**Re: Zoning By-law Amendment D02-02-21-0008 and Site Plan Control D07-12-21-0015
120 Den Hagg Drive
Phase 1**

Please accept this fourth submission for site plan approval for the above referenced project as a follow up to your circulation comments received on March 6 and 16, 2023. To this end, attached are the following documents for your information:

Circulation Comments and Responses

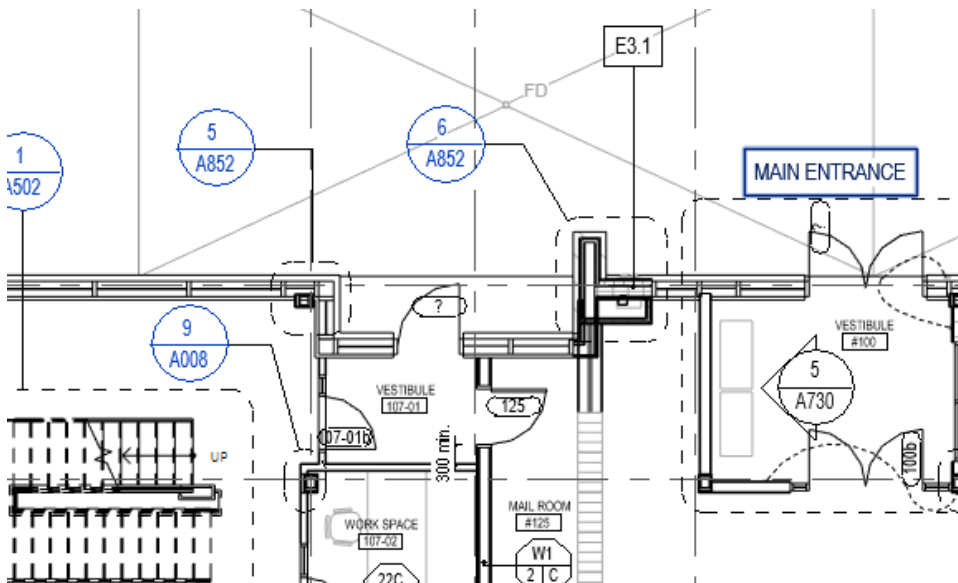
3. On the floor plans, a. A new triangular exterior space is now introduced next to the main entrance of the building. This new design appears to be out of place for the proposal (see below in the attached image)

Response: Triangular exterior entrance has been revised orthogonal. See screen shot below...

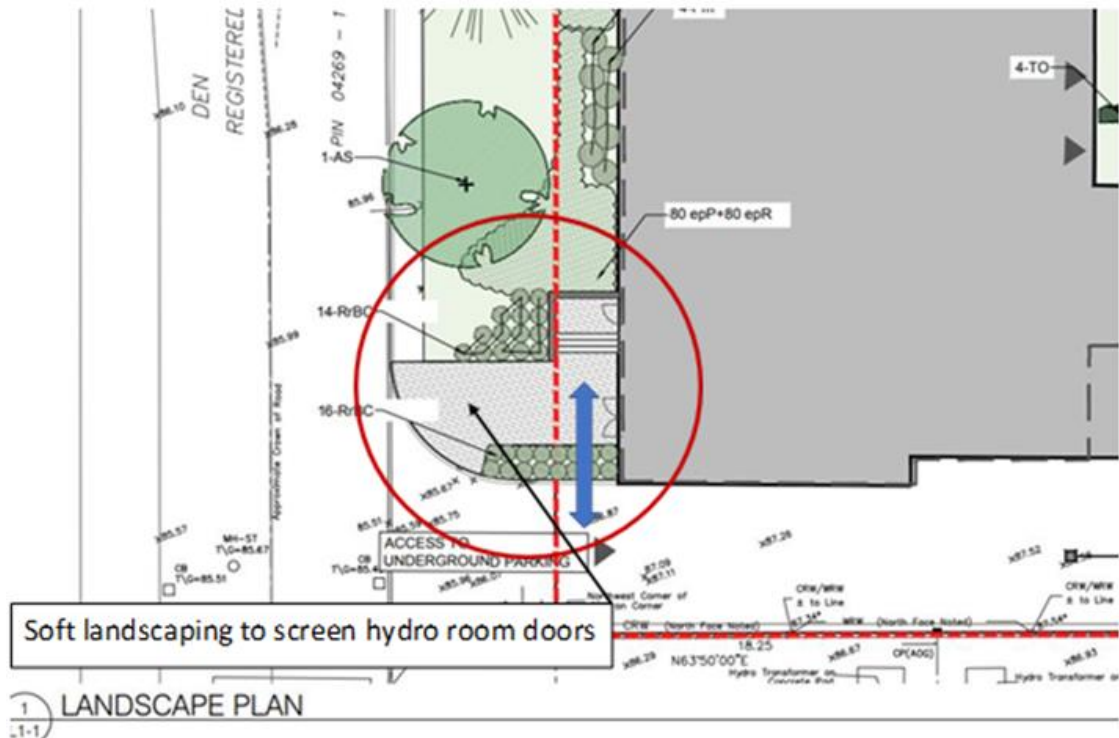
- Provide a detail of these lockups on plan.

Response: See attached L3-01, Detail 3 for Bike Rack on Unit Paving.
